Docket Number:	24-OPT-03
Project Title:	Soda Mountain Solar
TN #:	267972
Document Title:	MM HYD-1
Description:	This document describes mitigation measure HYD-1.
Filer:	Hannah Arkin
Organization:	Resolution Environmental
Submitter Role:	Applicant Representative
Submission Date:	12/18/2025 4:44:40 PM
Docketed Date:	12/18/2025

Mitigation Measure MM HYD-1
Soda Mountain Solar Project
California Energy Commission Opt-In Application 24-OPT-03

Attachment 1. Soda Mt. Revised Drainage Plan

Date: December 11, 2025
To: Hannah Arkin, Resolution Environmental
From: Tory R. Walker, PE, CFM, QISP
Subject: Soda Mountain Solar Project – Revised Drainage Plan

VEGETATED/ROCK LINED SWALE CROSS SECTION
NO SCALE

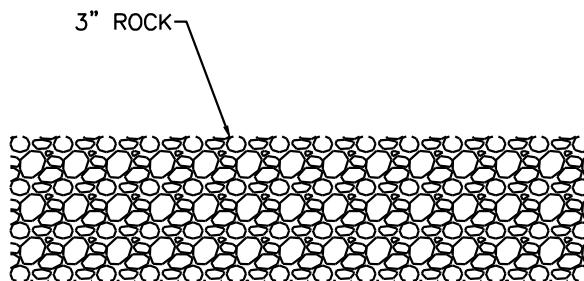
Elevation and grading/compaction of pads is anticipated for the BESS yards, substation and switchyard. With that disturbance and grading/compaction, some concentration and increase of runoff and erosion is anticipated, absent mitigating countermeasures. These countermeasures are anticipated to include small rock-lined swales adjacent to the pads to capture and infiltrate increased runoff. Excess runoff, not greater than existing flowrates, will be allowed to overtop the swales in the same manner as they currently flow (i.e., distributed, not concentrated), thus minimizing erosion potential to a level of non-significance.

STABILIZED ACCESS ROAD AT NATURAL CHANNEL CROSSING
NO SCALE

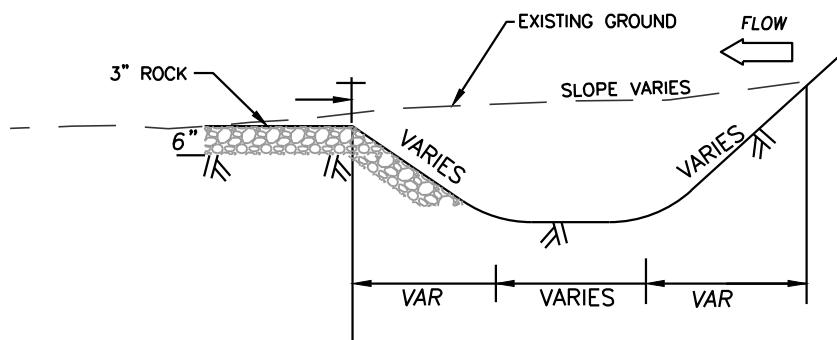
Increased runoff from the (disturbed and compacted) access roads will be dissipated and infiltrated onsite within the alluvial soils immediately downgradient of the roads, resulting in no significant increase in runoff or erosion. Where these access roads must cross shallow seasonal drainage paths, small diameter (e.g., 3-inch) rock may be used where needed to stabilize the road surface, as localized erosion/scour may otherwise occur in a major storm event. As the rock will be installed at existing grades, no disruption of grades leading to erosion/scour will occur.

MITIGATION COUNTERMEASURES
SODA MOUNTAIN SOLAR PROJECT
DECEMBER 2025

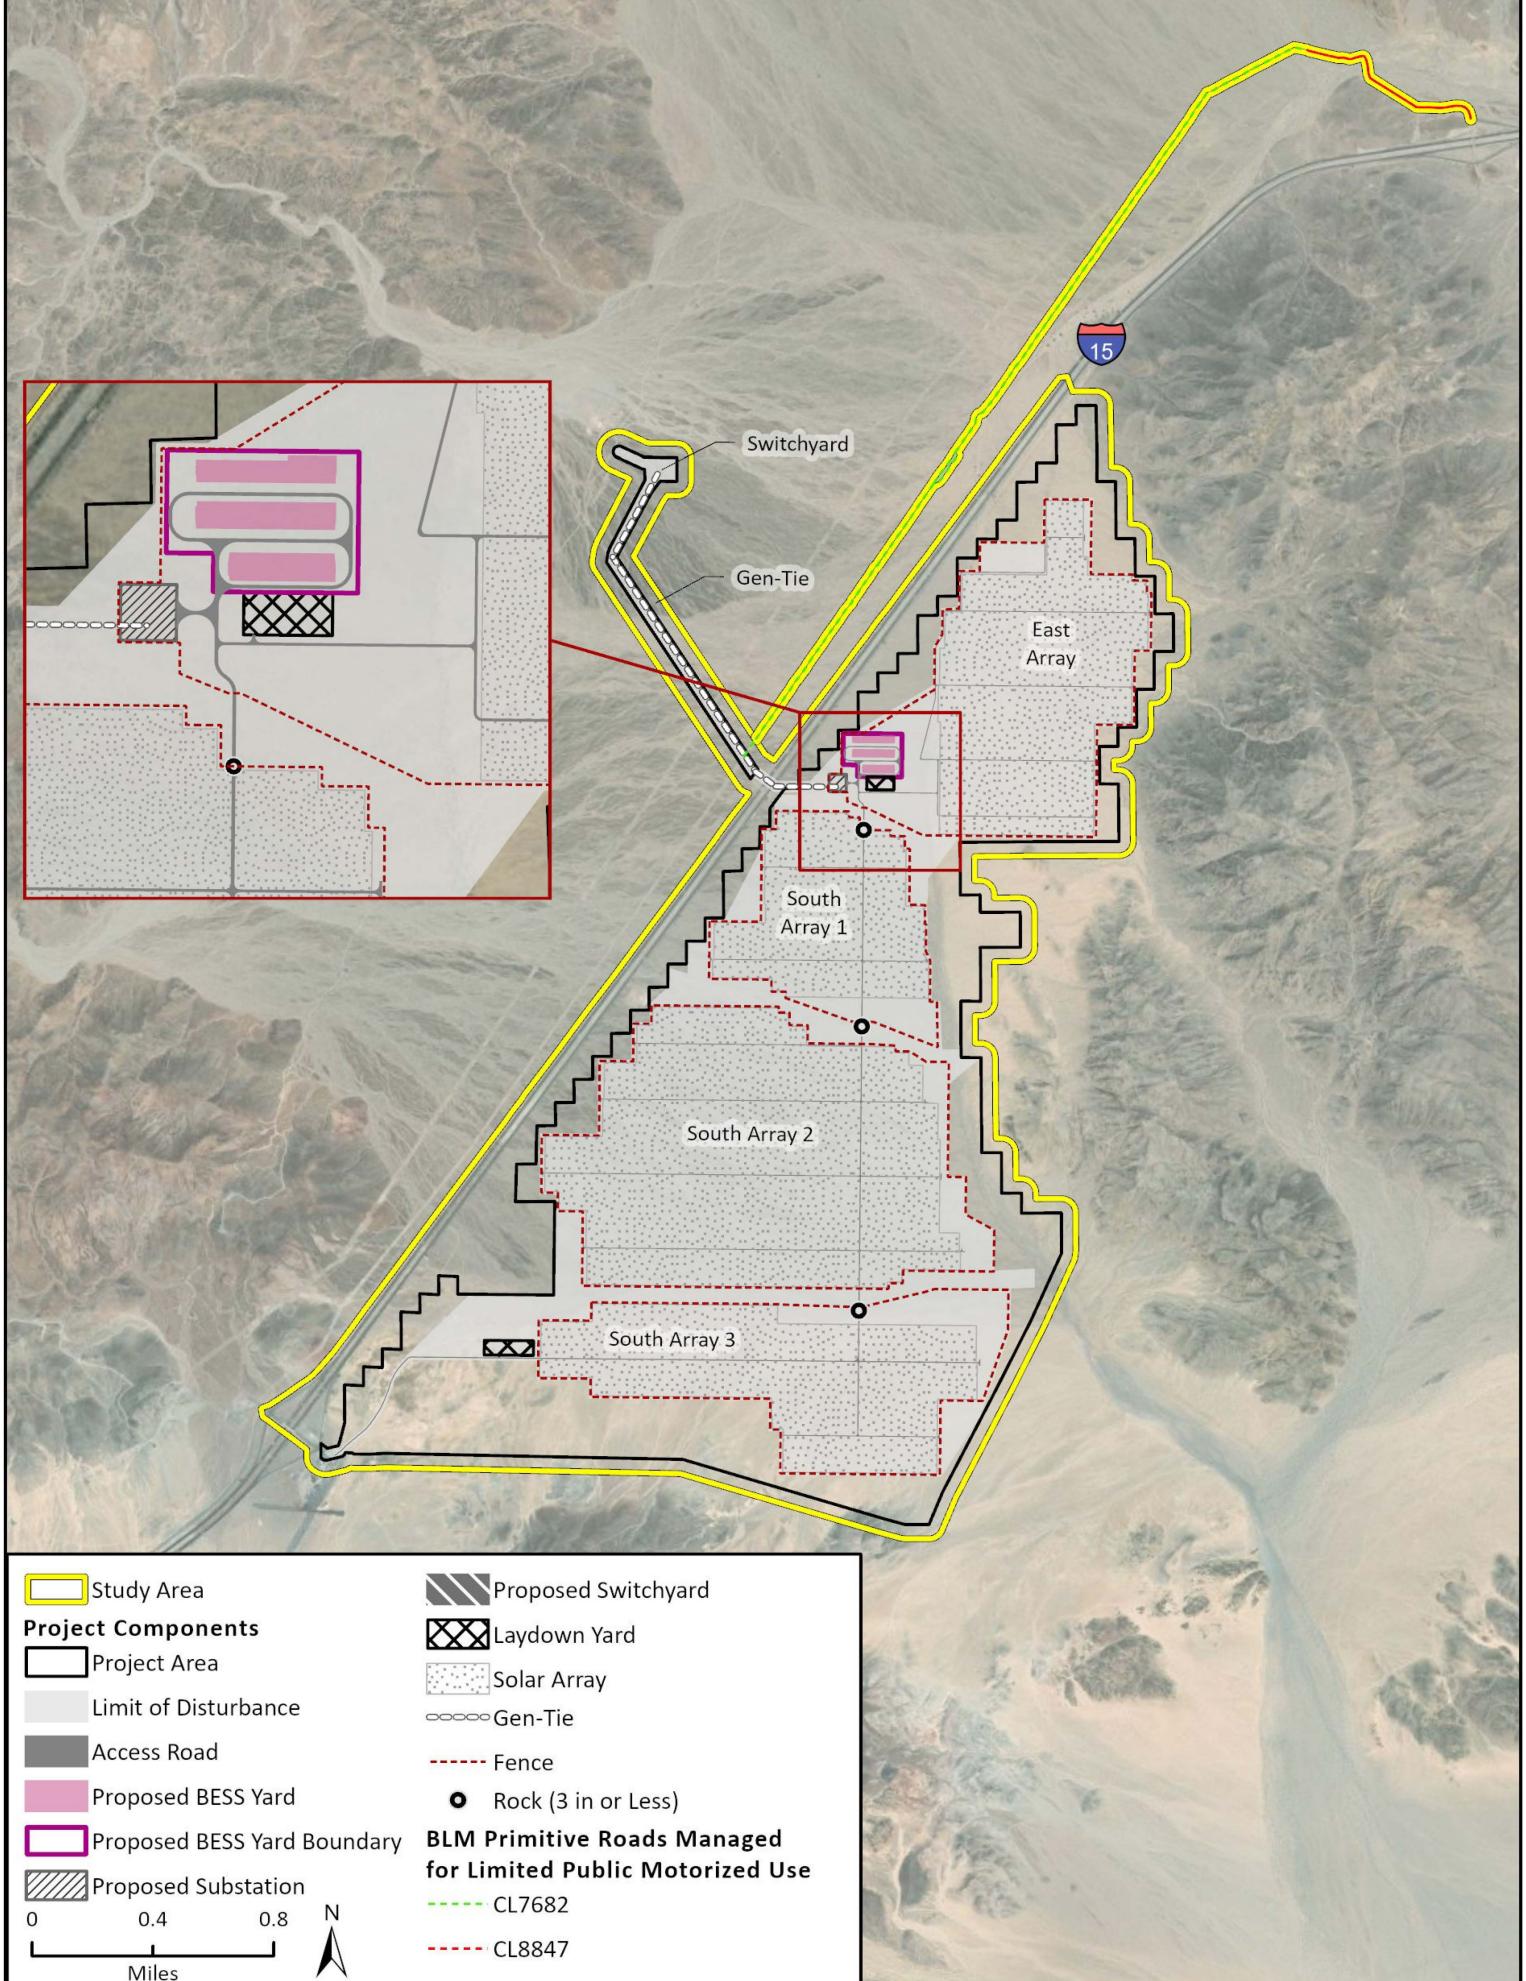
The proposed design thus minimizes both temporary and permanent disturbance of existing vegetation, soils and drainage patterns. No temporary or permanent berms or channels are proposed, and only very localized mitigating countermeasures are proposed where needed to ensure no significant impacts will result. These are illustrated on the attached exhibit.
